Determination 2010/003

Refusal to issue a building consent for cladding remediation work to a house and garage building at 7 Kane Street, Opuia

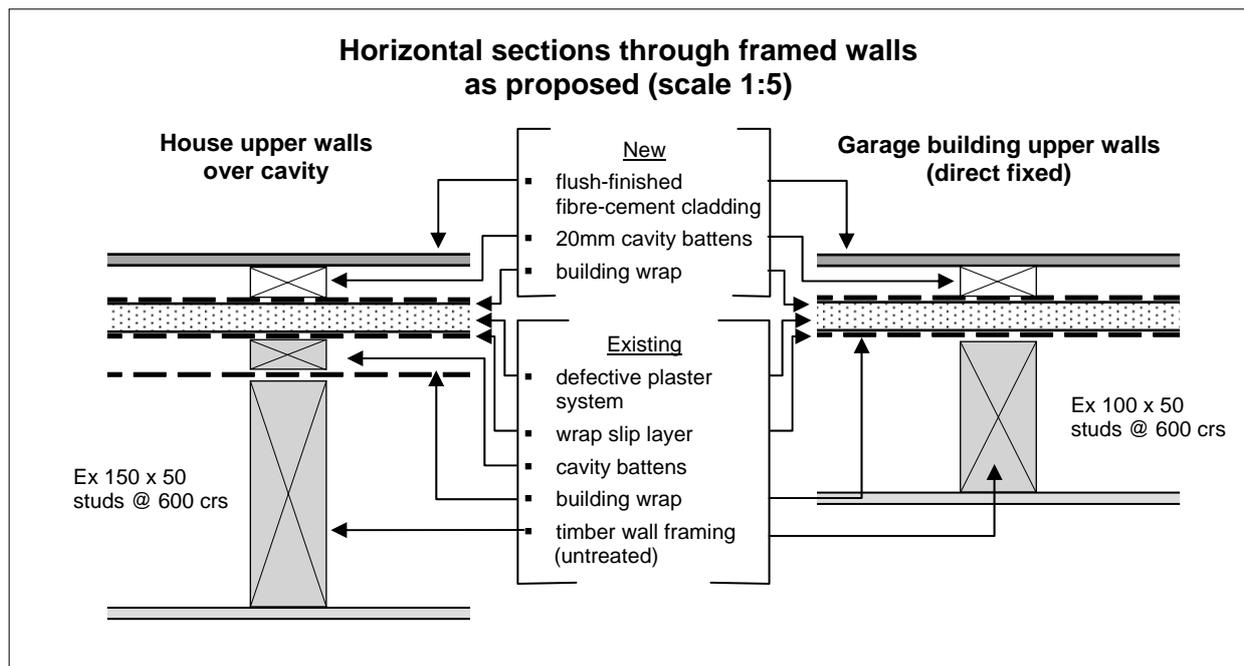
- 2.7.3 New colour-coated steel flashings, specified to be ‘texture coated’, are shown extending from the existing flashings to overlap the new cladding. The existing parapet flashings are to be retained, with a note stating ‘existing cap flashing to be dismantled and adjusted to fully enclose cavity based cladding’.
- 2.7.4 New apron flashings are shown at the junctions of the walls with the decks and canopies. Although not detailed, the proposed scope of works also includes the installation of new ridge flashings to the current single lengths of the roofs.
- 2.7.5 The specification calls for the plaster to the curved ensuite roof to be covered with a ‘composite fibreglass’ membrane, which is to be taken over the junction with the walls and up behind the new cladding. New butyl rubber membrane is to be installed to the roof gutters and the entry canopy.

- The removal of the parapet plaster cladding around the house is necessary to establish the extent of damage to the untreated structural timber to the parapet and adjacent areas.

- The areas walls requiring remedial work are generally relatively small but contain a large number of fixings, penetrations, and junctions. The re-cladding proposal requires purpose-made flashings for each junction and the like. The re-cladding makes little, if any, use of the use of manufactures’ standard installation details.

- The re-cladding proposal to the house will provide a finished cladding system in excess of 70mm thick (the cladding to the garage is approximately 50mm thick). The ability of the existing stucco to accept the new cladding in my view

is not fully resolved, with respect to the adequacy of the fixings (in both tension and shear loads) and the effect of the new cladding on the stucco itself. (The manufacturer installation instructions show the new fibre-cement cladding is to be fixed with 60x3.15mm nails with the nails providing fixing to the timber framing.)

- The installation of new flashings onto the existing flashing systems places reliance on the original flashings being watertight, particularly at the junction of the window jambs and sill flashings, yet the proper performance of these original flashing junctions has not been established. The new window sill flashing, as it is detailed in the re-cladding proposal, is unable to be stop-ended beyond the full extent of the jamb flashing.
- The specification refers to areas of stucco ‘containing fractures [to] have sections removed’ for inspection prior to installing the new cavity battens. Some sections of stucco wall have a large number fractures so the situation may arise where little of the original stucco remains.
- The re-cladding proposal does not describe what is to happen to those locations where the original cladding is removed.
